## IEEE P802.11

### Wireless Access Method and Physical Layer Specification

#### Section 2 Response to Draft D1 Letter Ballot processed at March 1995 meeting

**Abstract:** This paper presents the Section 2 Response to the Draft D1 Letter Ballot processed at March 1995 meeting.

[DB11]Figure 2-8: Relationship Between State Variables and Services

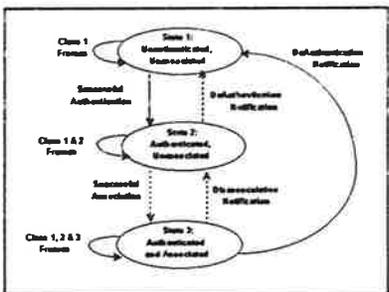
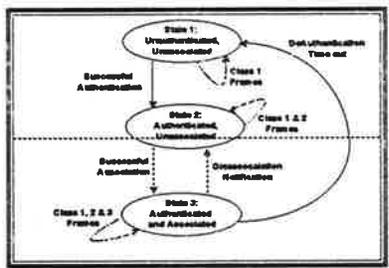
The state diagram needs to be corrected. It was noted at the Nov 94 mtg that there is an error in that there is not way to transition back from state 2 to state 1 (except via state 3 which is impossible in an IBSS network).

recommendation: accept set of changes that support the missing transition. this includes supporting change in sec 4 also.

To solve this I have added the missing state transition. Since the act of de-authentication is analogous to disassociation and is done for similar reasons, a message to notify the other station of the event also had to be added to section 4. The previous time out condition can still occur (so that authentication can be aged) and will now result in the de-authentication notification.

The set of changes which accomplish this correction are annotated as "deauthentication".
